Draft copy of modified Dwg No. CWS/E3/3/SK-1/0132 for set of Cable Tray

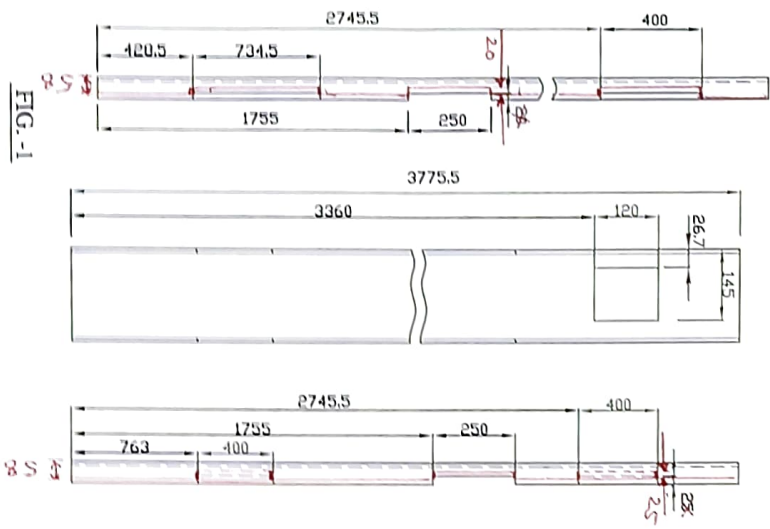
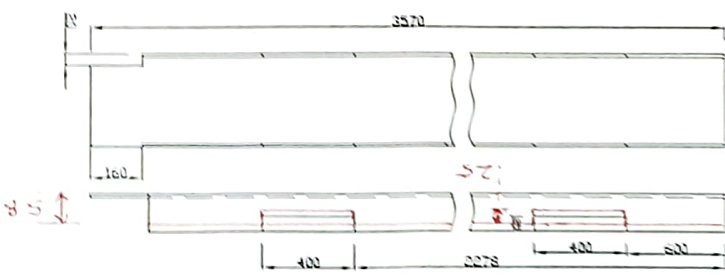
Note: (i) Height reduced from 65 mm to 58 mm, keeping all other dimensions are remain same.
(ii) modifications indicated in Red.
